DATE: March 13, 2010
TO: Michael J. Gillis, Virginia Correctional Enterprises Document Management Services
FROM: Jo Anna Ripley, Stormwater
PO: 270712
RE: Files Approved for Scanning

Project Name: KINGDOM HALL OF JEHOVAH'S WITNESSES
Structure/BMP Name: PC 110
Project Location: 5493 MOORETOWN RD
BMP Location: REAR OF SITE
County Plan No.: SP - 104 - 99

RECORD DRAWING
DETENTION BASIN / BMP
KINGDOM HALL
OF
JEHOVAH'S WITNESSES
5493 MOORETOWN ROAD
JAMES CITY COUNTY, VIRGINIA
SCALE: 1"=20' DATE: 12/11/00

SITE PLAN FOR KINGDOM HALL OF JEHOVAH'S WITNESSES JAMES CITY COUNTY, VIRGINIA

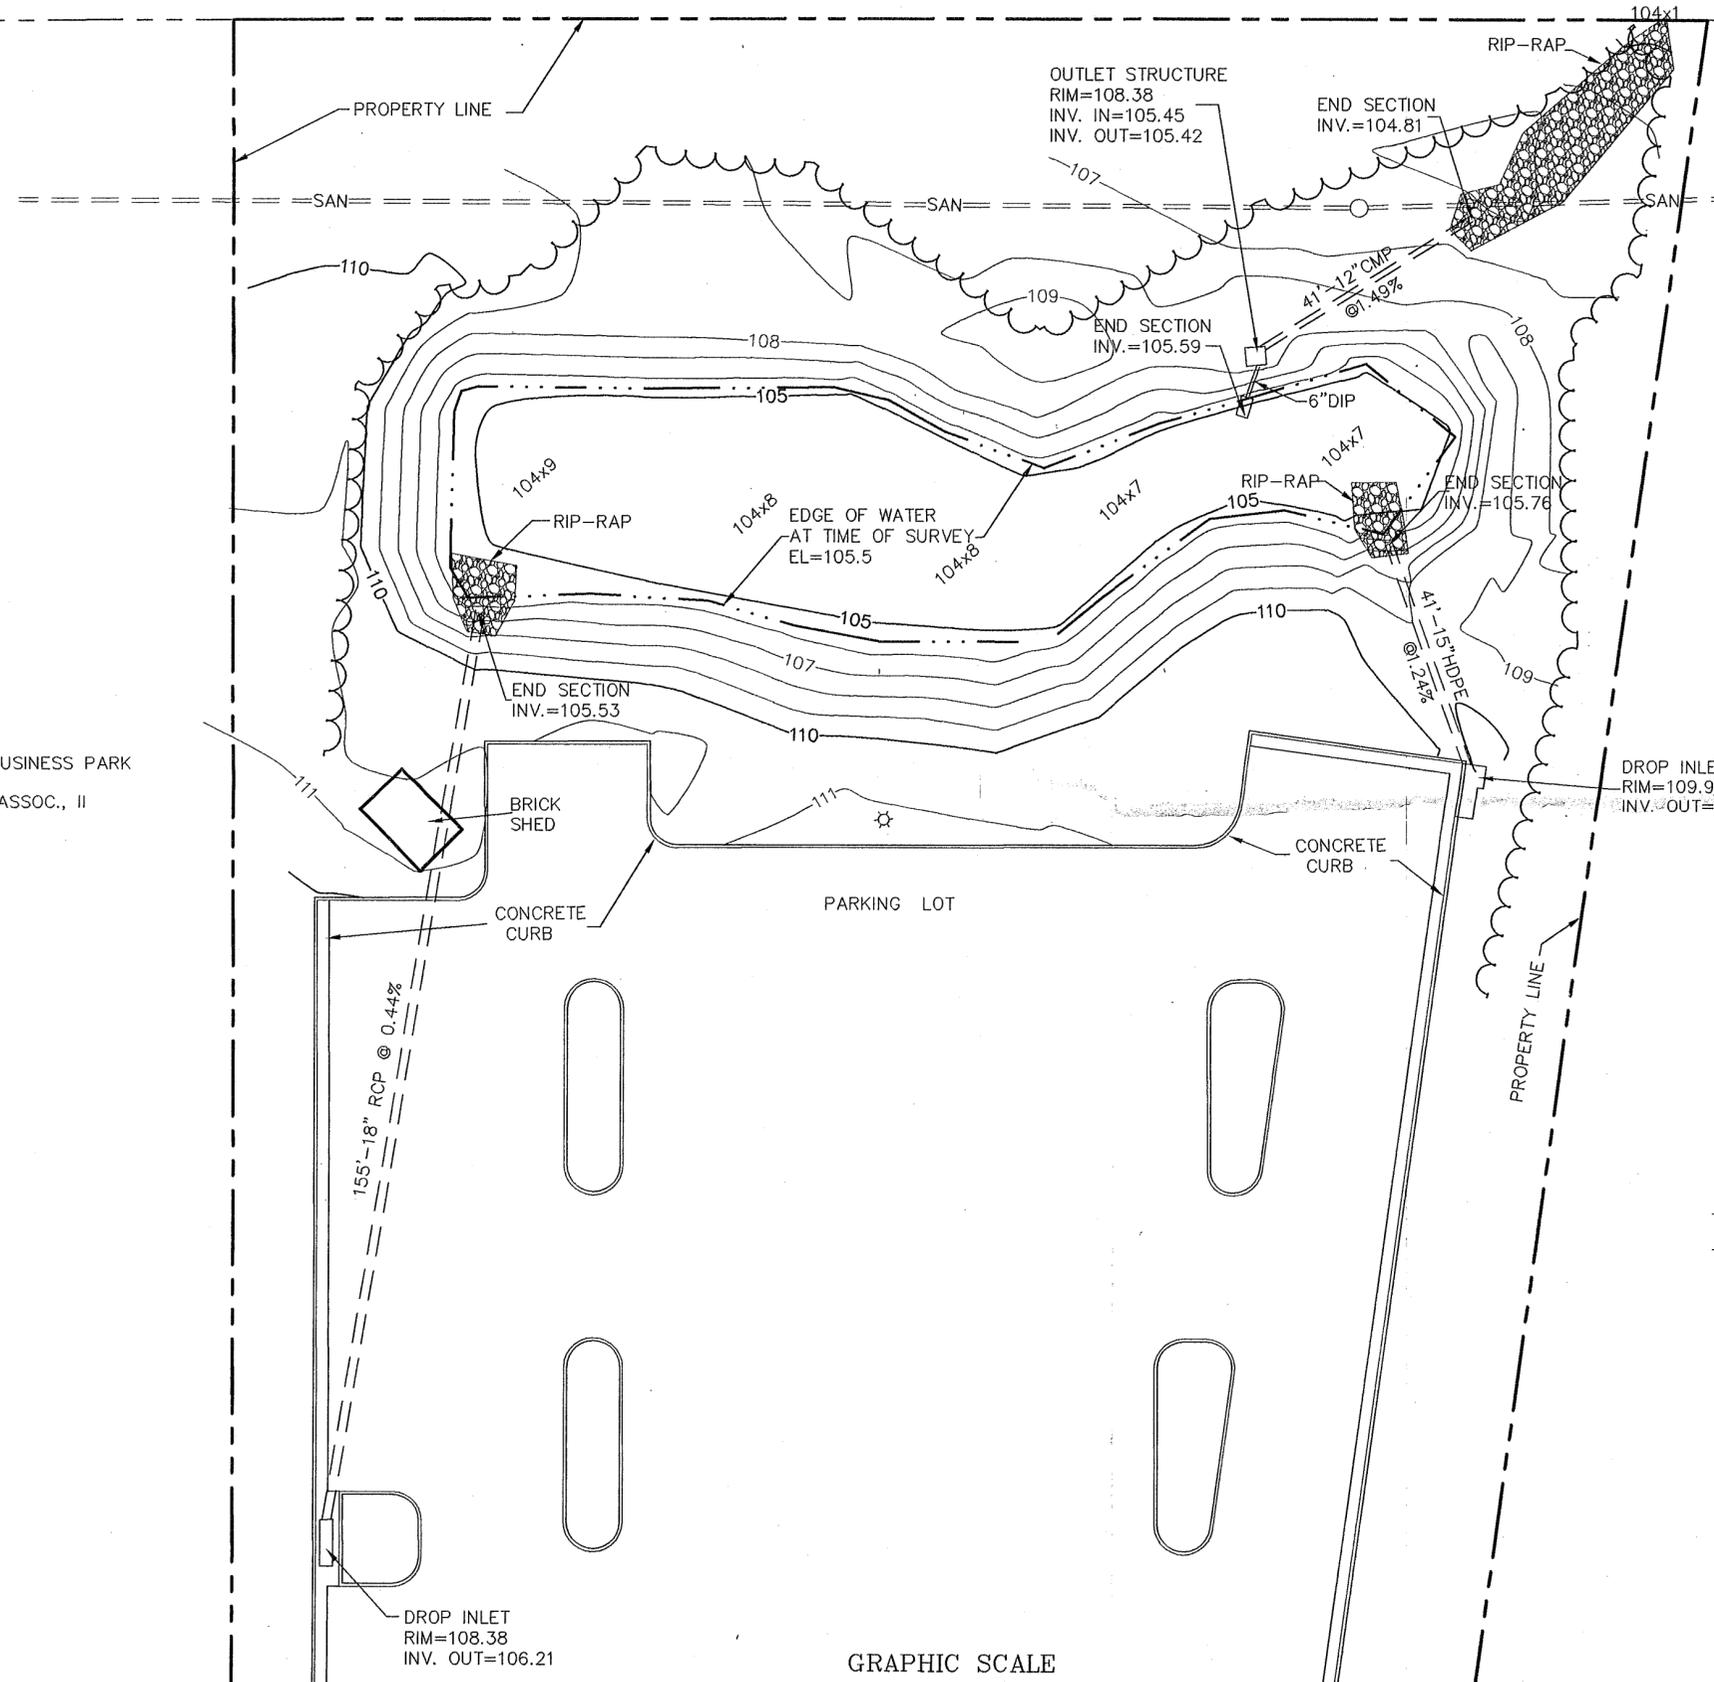
CSX TRANSPORTATION
100' R/W
*need more
SM-T STUBS
TO VERIFY*

*SHOW
PRINCIPAL SWALLMAY
DETAIL
SHEET C-3*

*INCREASED
OFFSITE
FLOODING*
*Added
Vol int.*

RECORD DRAWING
DETENTION BASIN / BMP
KINGDOM HALL
OF
JEHOVAH'S WITNESSES
5493 MOORETOWN ROAD
JAMES CITY COUNTY, VIRGINIA
SCALE: 1"=20' DATE: 12/11/00

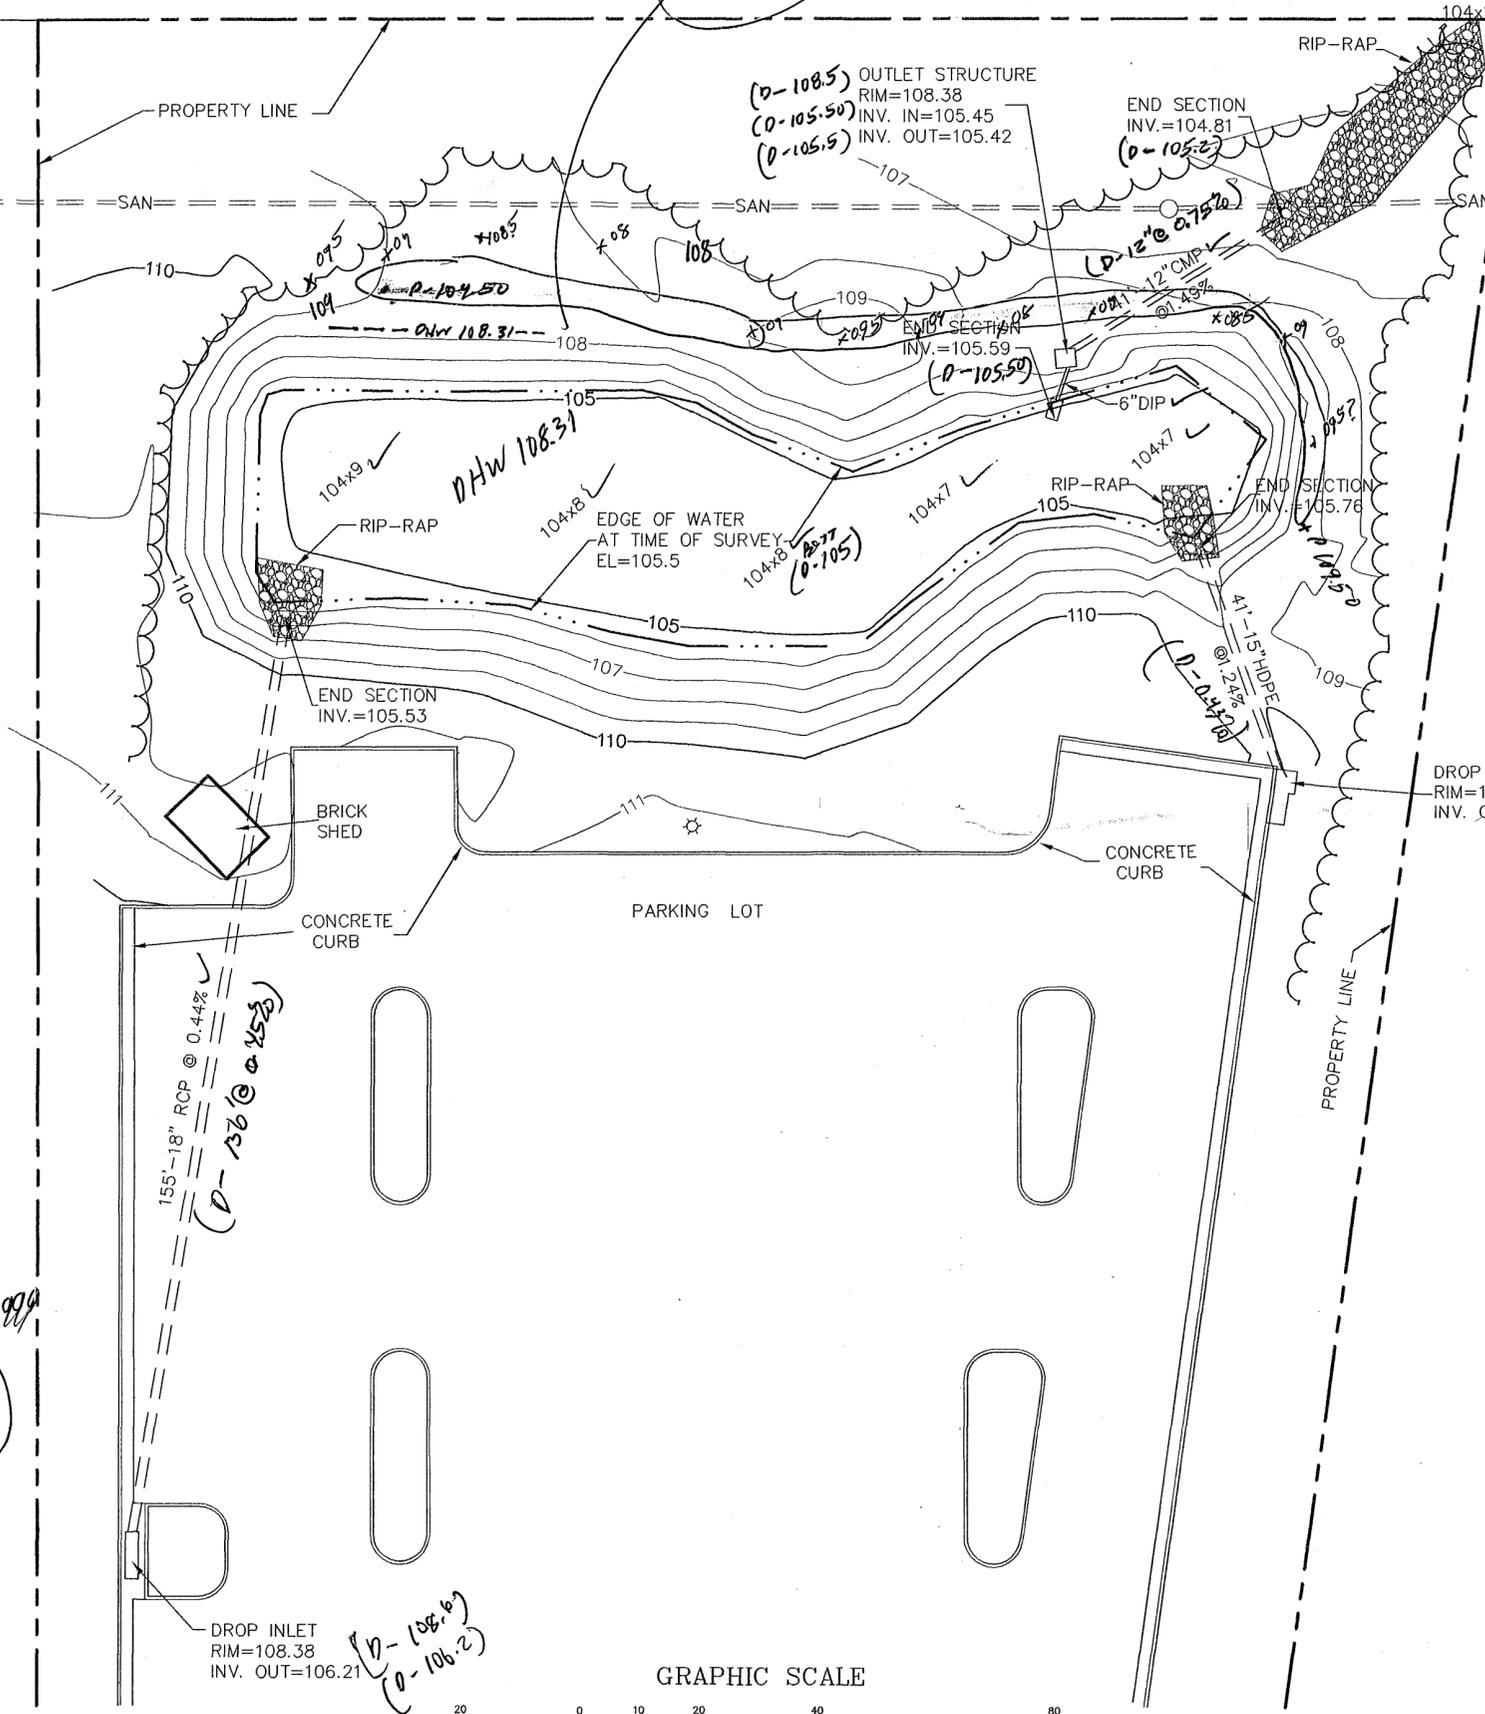
*SHALLOW
MARSH PLANTINGS
PER APPROVED
LANDSCAPE PLAN
SHEET (L-1) AND
AND
CBPOrd exception
request letter
dated Dec 30 2000
(C. Moore to
Stephen Romeo.)*

RECORD DRAWING DETENTION BASIN / BMP KINGDOM HALL OF JEHOVAH'S WITNESSES 5493 MOORETOWN ROAD JAMES CITY COUNTY, VIRGINIA SCALE: 1"=20' DATE: 12/11/00 REVISED 01/18/01

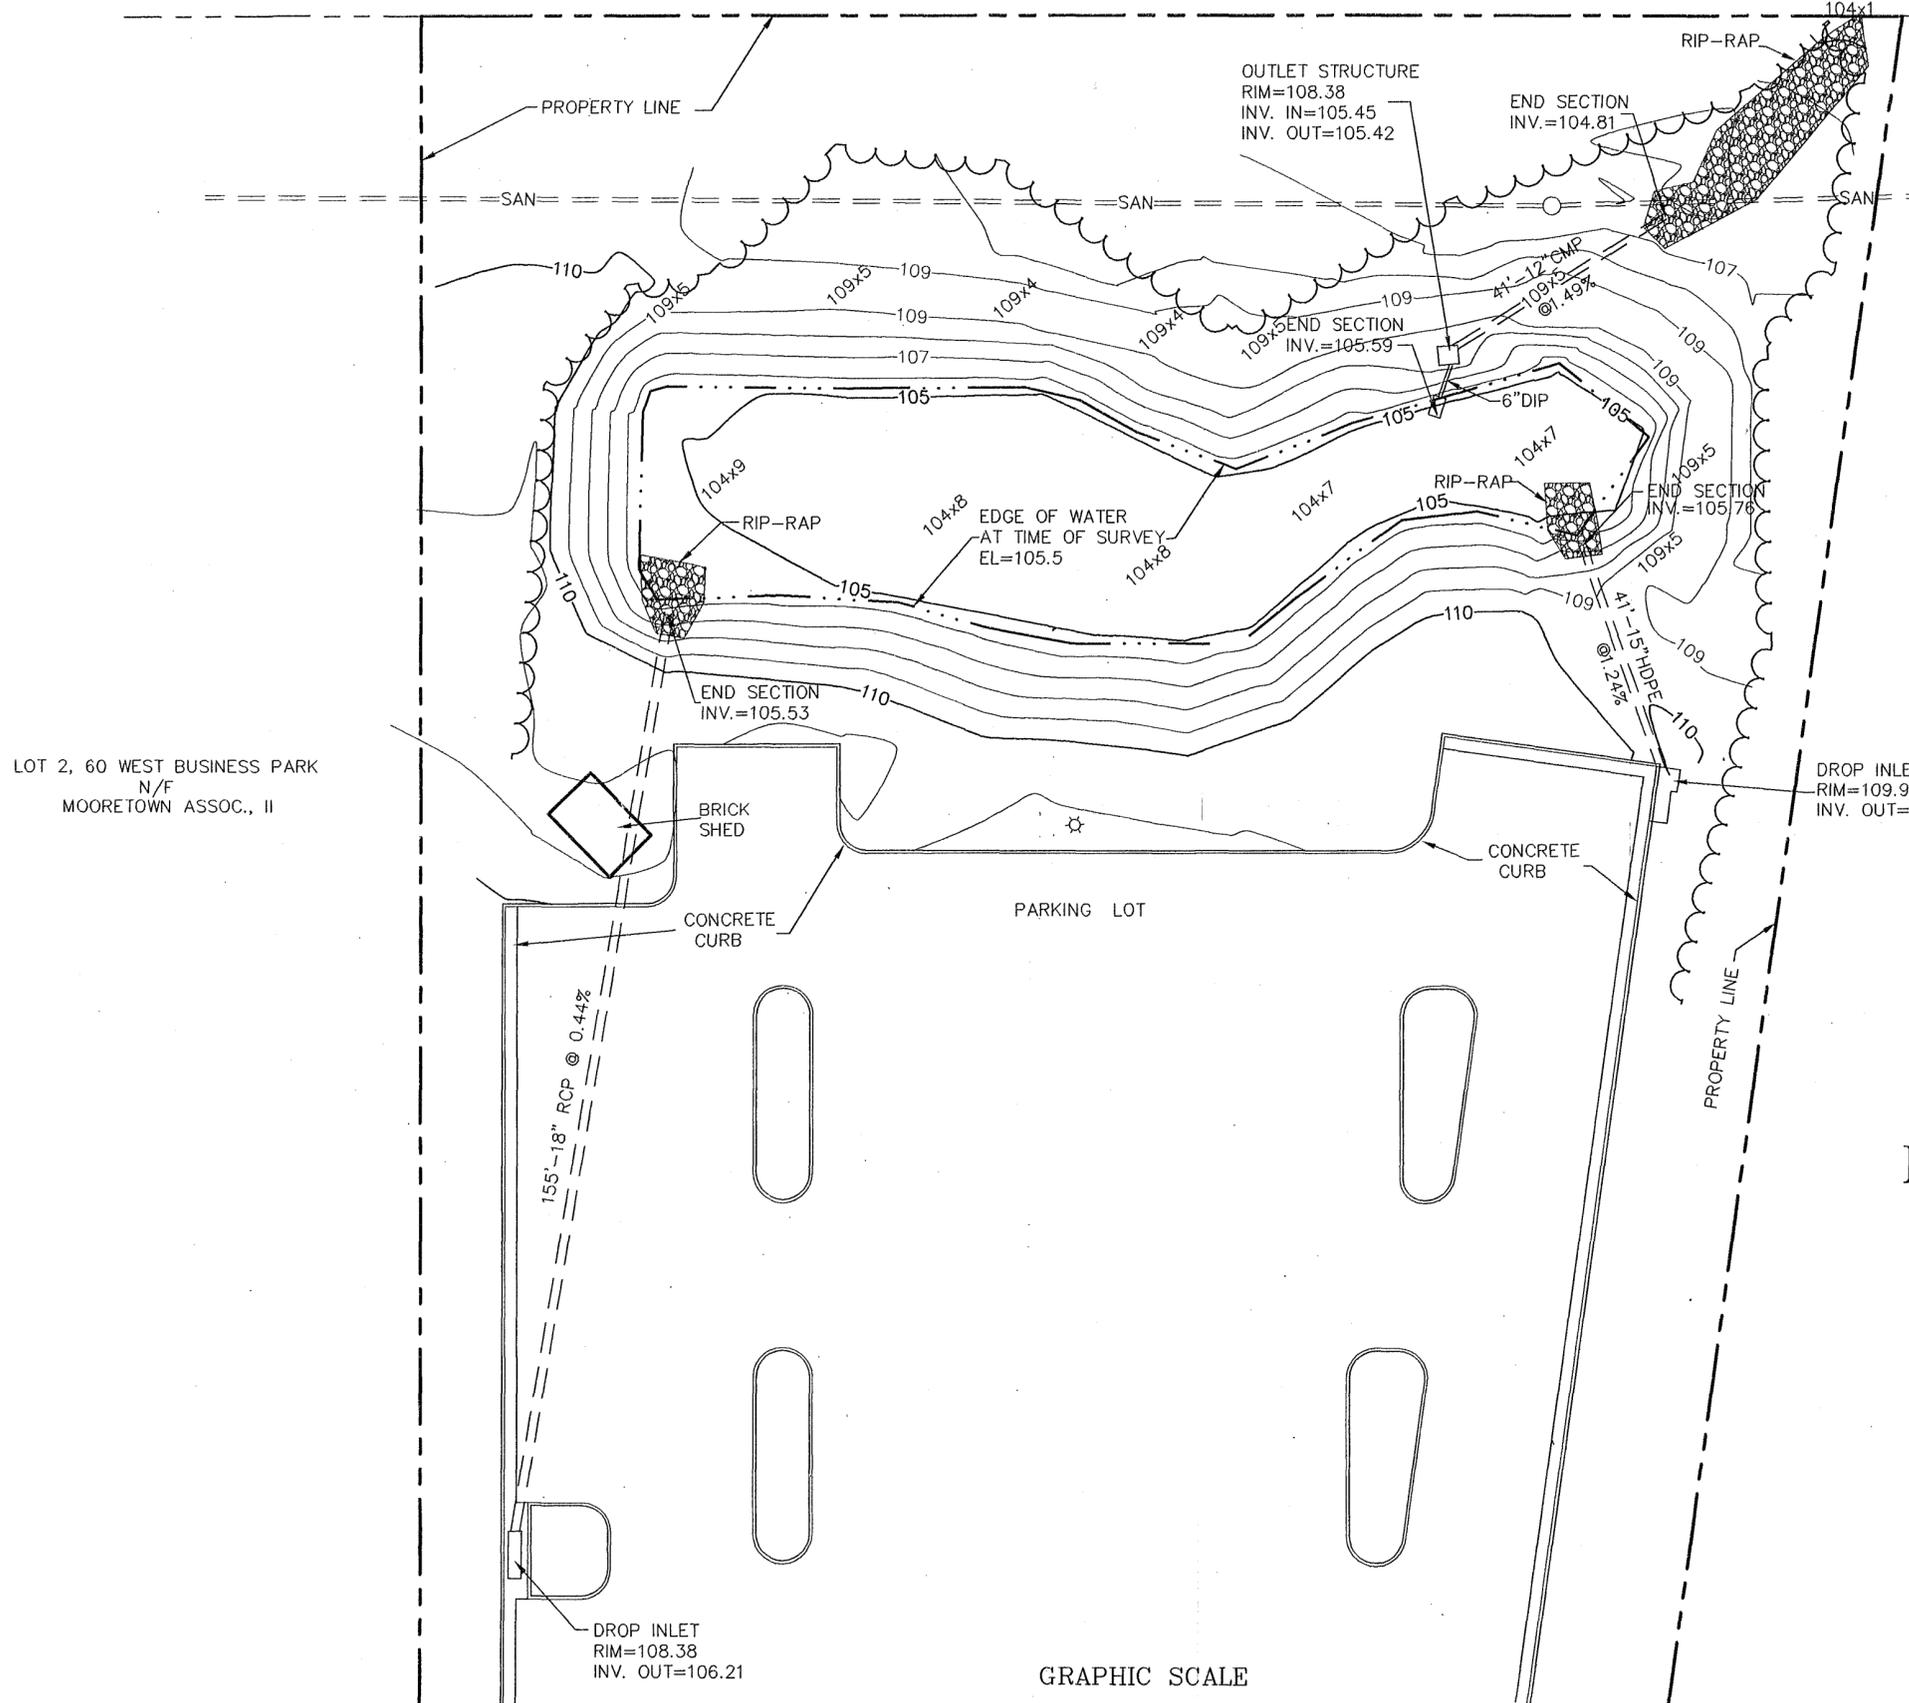
HOLD
WAITING FOR CC &
COMPLETION OF CR ITEMS

RD
PREV Comm #2 12/22 NA.
PREV Comm #3 12/22 OK
PREV Comm #4 12/22 NA
NO MYLAR

Notes: Drawing updated to reflect additional dam grading by sitework contractor pursuant to your 12-22-00 letter.
Correspondence regarding construction certification and inability of receiving channel to adequately convey runoff due to lack of maintenance forthcoming under separate cover.
